June 21, 2002
NG-02-0314

Subject: Duane Arnold Energy Center
Docket No: 50-331
Op. License No: DPR-49
Technical Specification Change Request (TSCR-050A)
“Proposed Changes to DAEC Technical Specifications Section 5.0,
Administrative Controls”

PROPOSED CHANGE TSCR-050A TO THE DUANE ARNOLD ENERGY CENTER
TECHNICAL SPECIFICATIONS

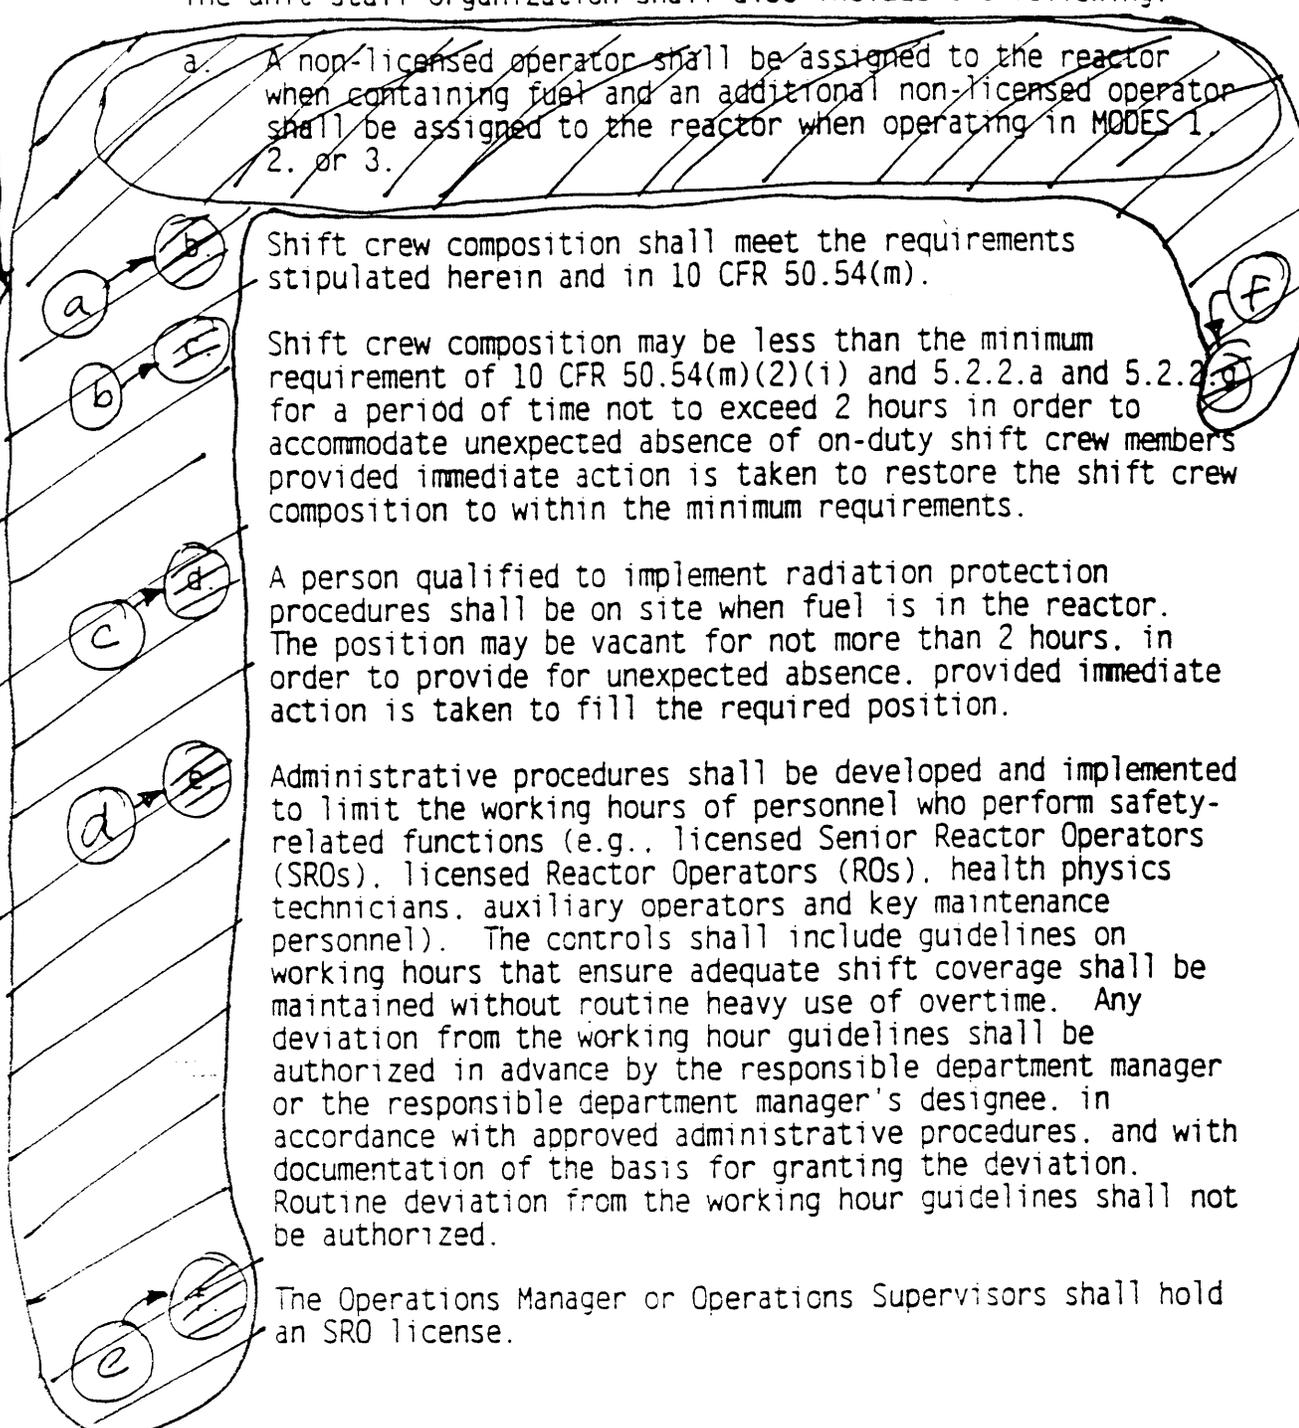
~~a. A non-licensed operator shall be assigned to the reactor when containing fuel and an additional non-licensed operator shall be assigned to the reactor when operating in MODES 1, 2, or 3.~~

This change is being withdrawn per TSCR-050A
